ROTAX
NEW AGE KARTING

CUSTOMER INFO

2010 12 20

NEW RADIATOR WITH FLAP 125 MAX, Junior MAX, 125 MAX DD2

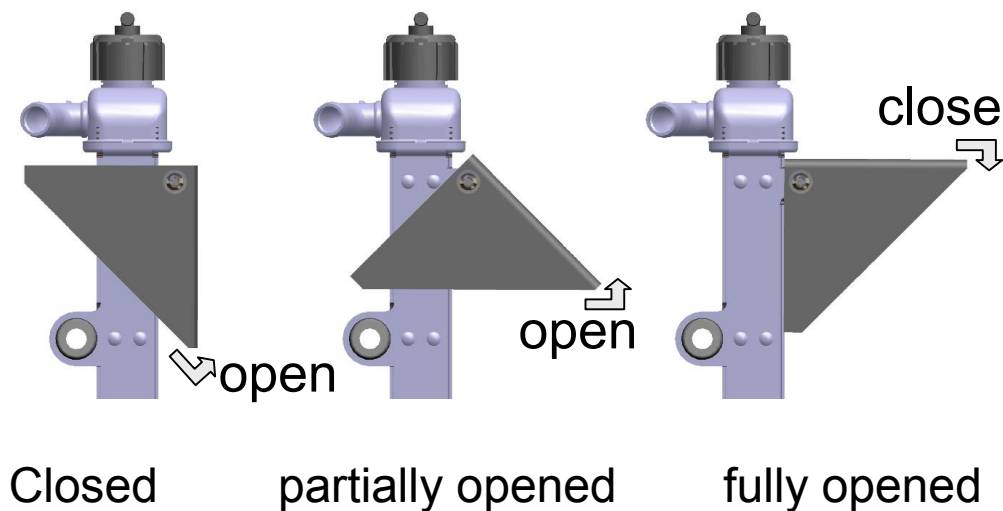
We are proud to inform you that, BRP-Powertrain established a new design radiator with adjustable cooling surface.

- Adjustable cooling area will minimize the need to tape the radiator at cold ambient temperatures
- Fully opened flap can reduce coolant temperature up to 3°C (Compared to actual radiator) at high ambient temperature.
- Improved fixation of the radiator to the engine to increase durability of the radiator.
- The force for the adjustment of the flap can be set individually by means of the 2 Allen screws and locking nuts.
- Quick engine warm up with closed flap (Compared to actual radiator)

- Take care not to close the flap completely (keep a distance between flap and radiator for the fingers) otherwise it is difficult to reopen the flap again!

Both configurations (old and new design) are legal to be used in the ROTAX MAX Challenge.
